Appeal NO: ABP 314485

From: Gareth O'Brien <gobrien@yupon.com>
Sent: Thursday 19 December 2024 15:38
To: Appeals2
Subject: PL06F.314485 supplementary submission RA Draft Decision
Attachments: PL06F.314485_GarethOBrien_NRTG_-_ABP_RA_Draft_Decision_Submission.pdf; daa Response on Bikerdike Allen Noise Modelling.pdf; Letter to Vanguardia.pdf; NRTG Letter to Declan Fitzpatrick ABP RA Submission.pdf

Bord Pleanála Case Number: ABP-314485-22

Planning Authority Case Reference: F20A/0668

Figure 1 2022 census data shows the sparsely populated area that Meath and Fingal have reserved for aircraft noise at the request of daa.

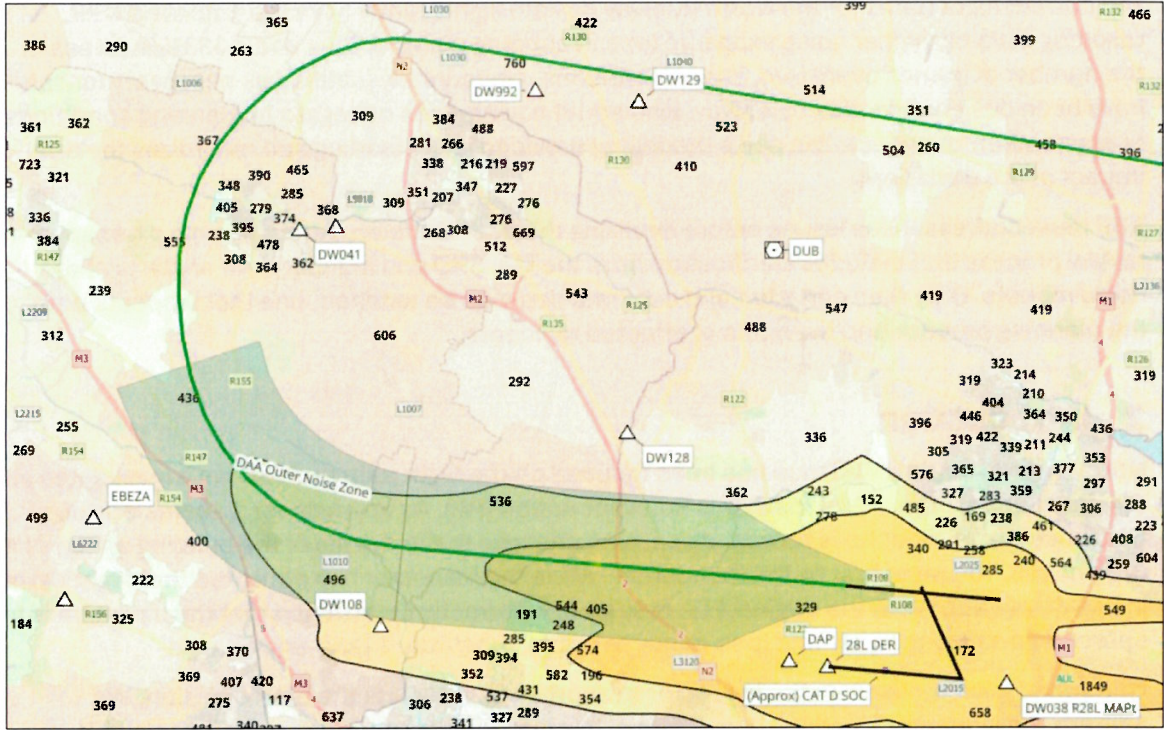
No comparative EIAR has been performed comparing the noise permitted by the original EIS to the present situation or the proposed scenario in the 2023 EIAR. We understand that ANCA has asked for this as part of the Infrastructure Application but the Applicant despite having now produced 19,000 pages for that application has still not provided it.

Figure 2 Original noise Bickerdike Allen Partners model as presented to ABP (A11267_19_DR039_2.0)

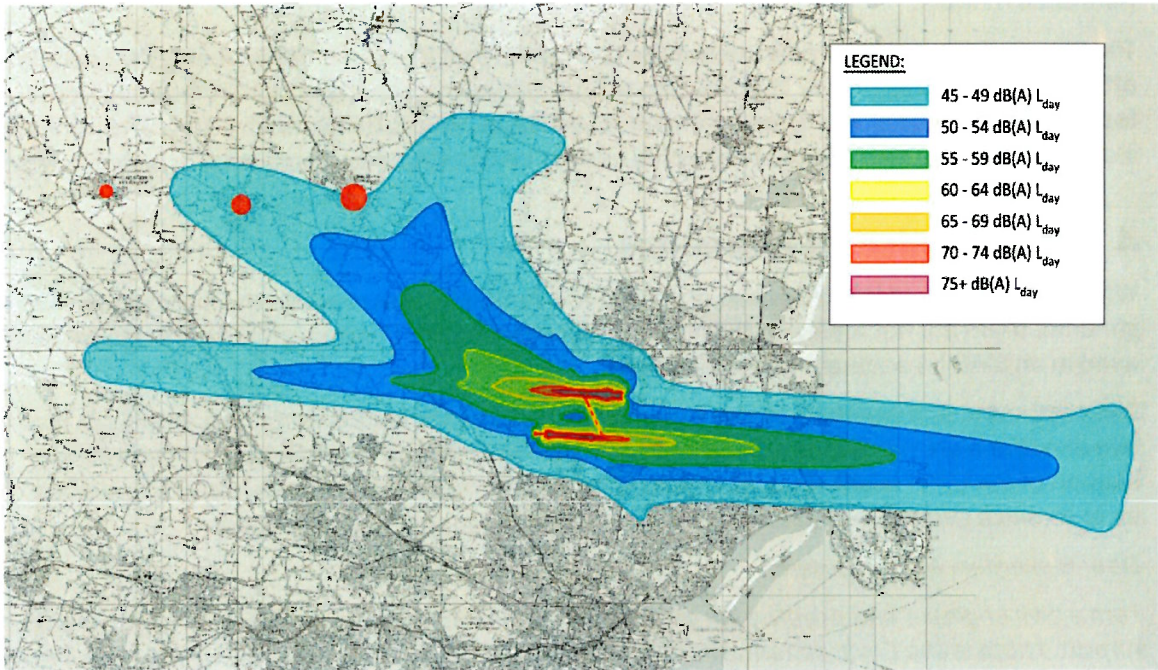
In your chart you show east-bound departures straight ahead from Runway 10R at maximum climb-efficiency reaching the 55db(A) line (green-blue boundary) at approximately 11.25km from departure end of the runway.

Departures from runway 28R towards the west enter a series of banked turns, undoubtedly reducing their climb-efficiency with the result that they must be closer to the ground for longer. However, in your chart you show 28R departures reaching the 55db(A) line much sooner at only 6.84km.

The westerly operations in this model should have noise zones that extend further from the departure end of the runway than those heading east. This based on the poorer climb performance of aircraft that are turning to follow the SID.

Figure 2 shows the model as supplied by BAP and it is apparent that the easterly zones are much longer, extending much further from the runway despite any aircraft would be climbing straight ahead which should be a more efficient climb.

Figure 3 The Dublin Airport Authority plc produced this “Landuse” drawing. For the Inspector to determine that deviation from these noise zones is “not a Land Use issue” is incomprehensible.

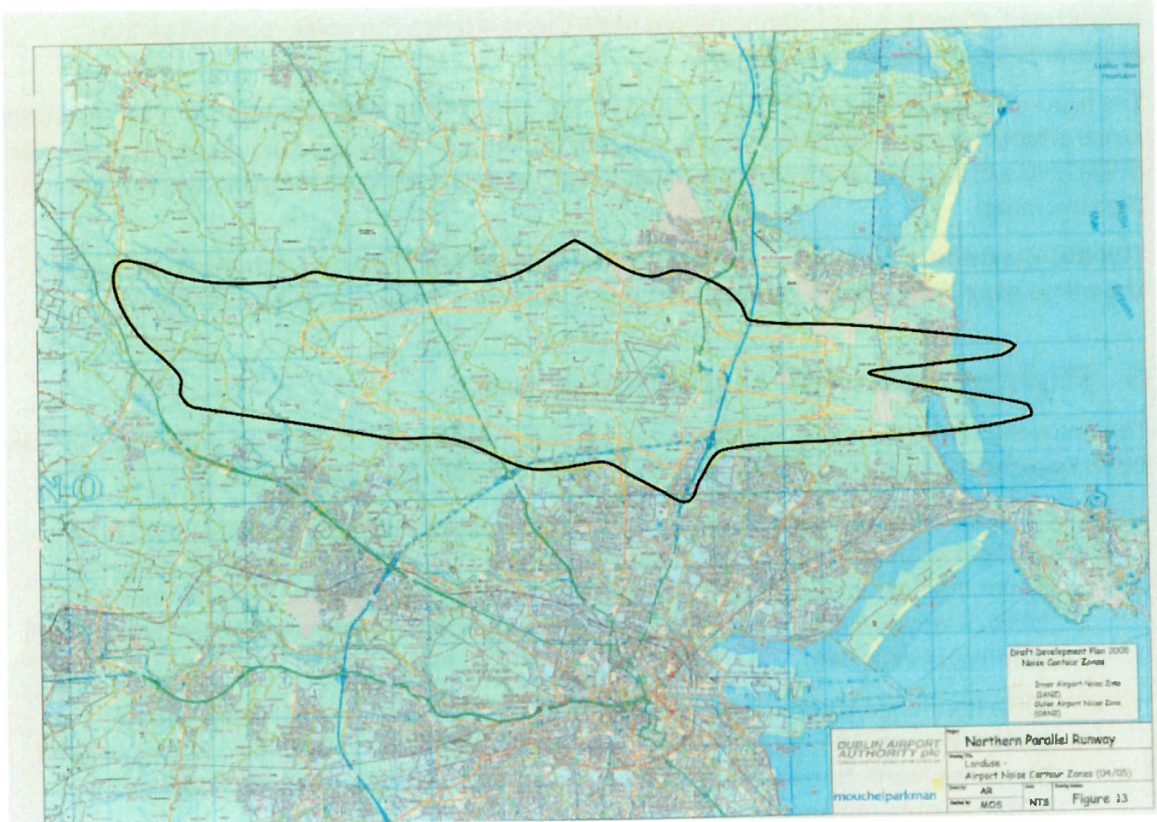
The Inspector has concluded that the deviation of the flight paths “is not a land use issue”. The noise zones requested by daa, approved by ABP and promulgated into the county development plans of Meath and Fingal are labelled “Landuse – Airport Noise Contour Zones (04/05)”. GIS analysis shows the approved route affects 932 houses while the deviated paths directly affect 3,115 houses with an additional 4,723 adjacent to the daa’s so-called Environmental Corridors. If an 840% increase in the number of households affected is not a land use issue, what is?

Figure 4 Published departure procedure for Runway 28R shows the heading deviations to 308 and 004 degrees from the runway heading of 278 degrees. These result in 30 and 86 degree deviations from runway heading, not 15.

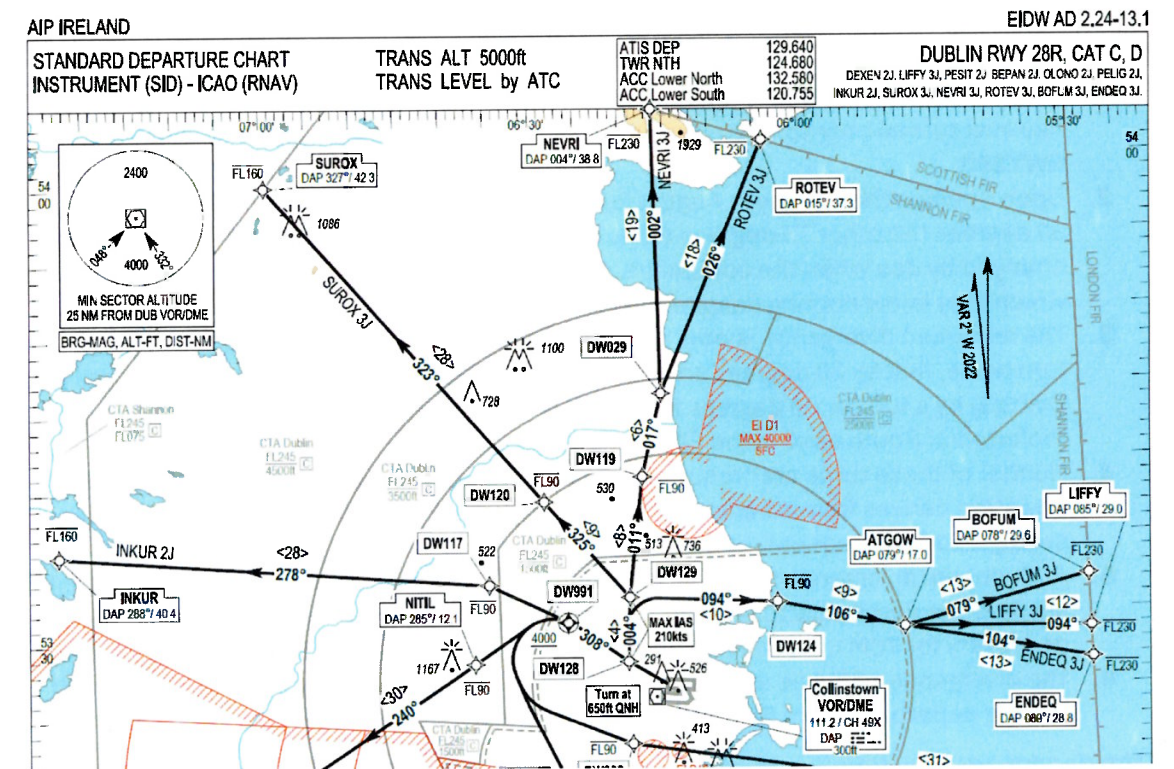
Far from a minor 15-degree operational change, it is a fundamental change to the EIS upon which the grant of permission was originally made. The change is strictly forbidden by Condition 1 of the granted permission. The Applicant’s position is akin to modifying the route of a motorway such that it is built 12km from where originally planned and pointing out that changing the speed-limit doesn’t need planning permission.

Approximately 55% of those aircraft turn again within **3 nautical miles** at DW128:
Heading 004 = an **additional 56-degree deviation** for a total of **86 degrees** deviation from the NPR.

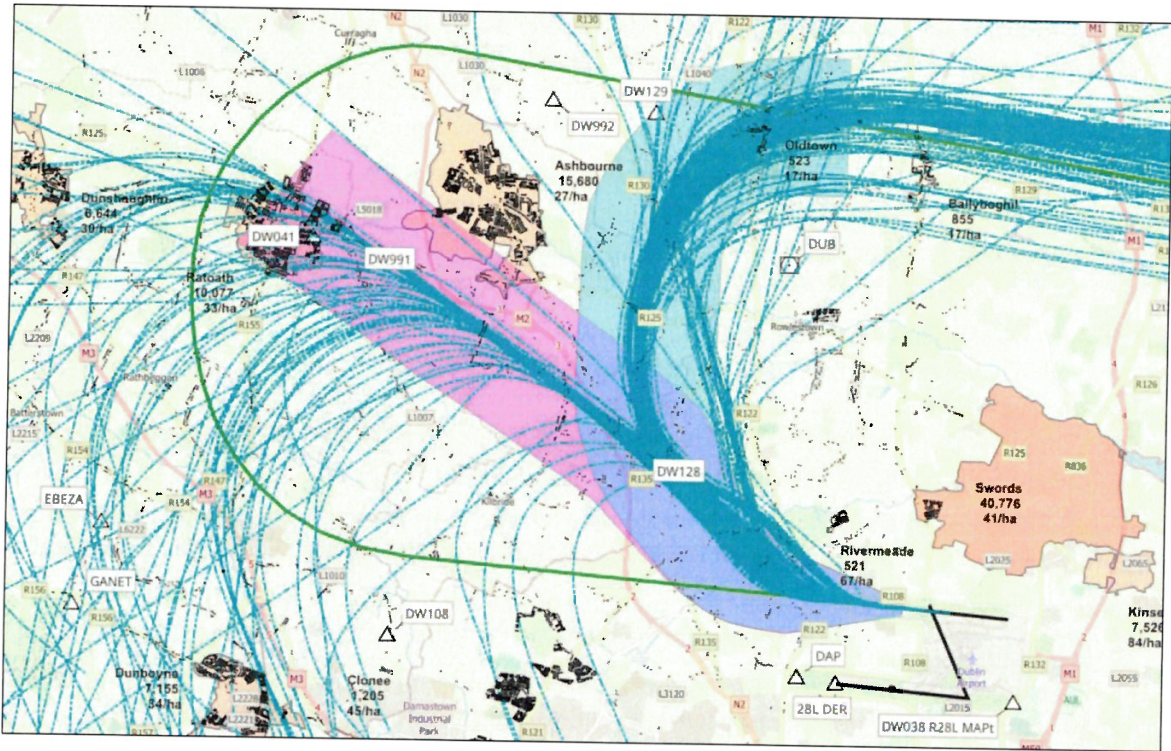
Analysis of the flight paths using GIS software and publicly available population and map data demonstrates the scope of the deviation from planning permission. The failure of daa to adhere to their EIS has increase the number of homes affected by the departure noise from 934 houses on the approved route to 3,115 houses directly affected within daa's so-called Environmental Corridor and an additional 4,723 houses adjacent to the flight paths. The Inspectors characterisation of this as not being a land-use change is unreasonable on its face.
